Better Back Roads Program Review

December 2015

Eden, East Hill Road

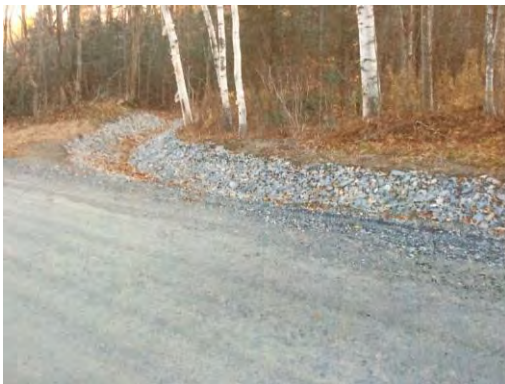
1. Were BMP's identified in the BBR manual proposed for the repair and were they properly applied?
Yes, ditches were lined well and turnouts were used to control the flow of water on these sites.
2. Effectiveness of BMP
BMP's were effective as the foreman was cleaning ditches for the first time after 10 years of service. We would like to see larger stone in the ditches to slow the flow of water during high runoff events.
3. Could additional funds be utilized at this site?
Yes, with more funding the town could have stone lined and ditched both sides of the road.

Mendon, Journey's End

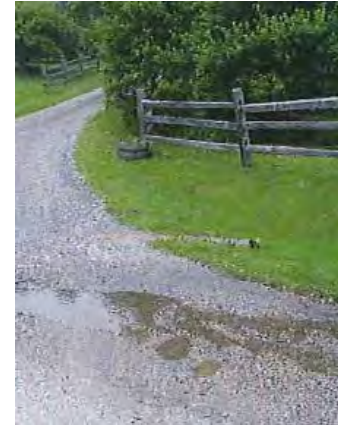
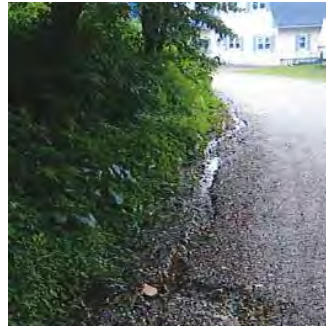
1. Were BMP's identified in the BBR manual proposed for the repair and were they properly applied?
BMP's were used, but ditches could have been deeper, as the water didn't sheet flow off the downhill side of the road. A couple of passes with a grader to change the cross slope of the road would fix this situation.
2. Effectiveness of BMP
BMP's were effective, but maintenance was not taken into consideration, especially with the placement of a catch basin on a dirt roadway.
3. Could additional funds be utilized at this site?
It appeared that the funding available was adequate for this site.

Craftsbury, Collinsville Rd

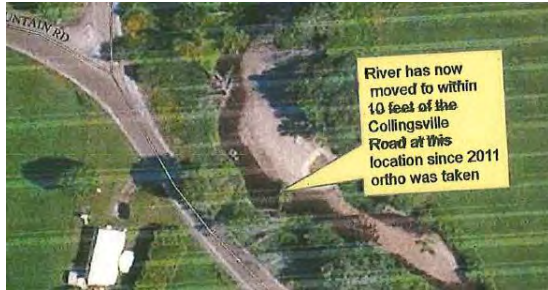
1. Were BMP's identified in the BBR manual proposed for the repair and were they properly applied?
BMP's were not used at this site as there were not applicable to this type of project. It is suggested that there is continued coordination with river management engineers.
2. Effectiveness of BMP
N/A. It is suggested that the town consider the project's impacts on downstream structures that are severely undersized and keep in working contact with river management engineers.
3. Could additional funds be utilized at this site?
Yes, this project requires significant funding for a proper fix though as there are so many undersized structures downstream and the river is currently in motion and incising.

Barnard, East Barnard Rd

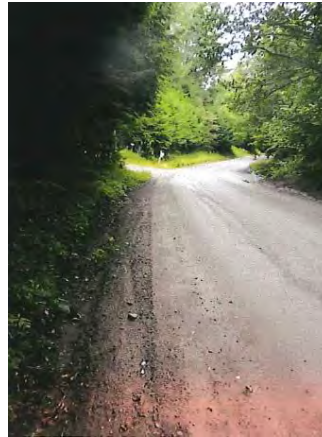
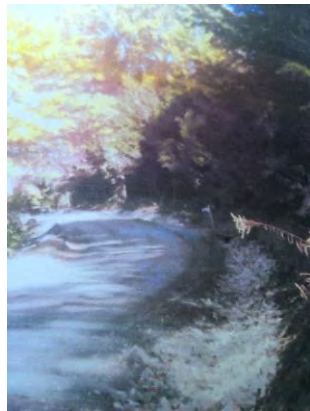
1. Were BMP's identified in the BBR manual proposed for the repair and were they properly applied?
BMP's were used. General and winter maintenance has created berms which channelizes the flow of water and has unintentionally created erosion issues. Upon review, the longevity of the solution may have been enhanced by stabilizing the slope rather than ditching. Proper grading could have eliminated the berm issue, and slopes should have been stabilized instead of trying to place a ditch. While not in the Better Backroads manual, it would be recommended to grade the road to sheet flow off and stabilize the slope issue.
2. Effectiveness of BMP
BMP's used were effective, but a different fix to this project may have resulted in a better solution.
3. Could additional funds be utilized at this site?
Yes, a proper fix at this site would require a significantly larger amount of funding.
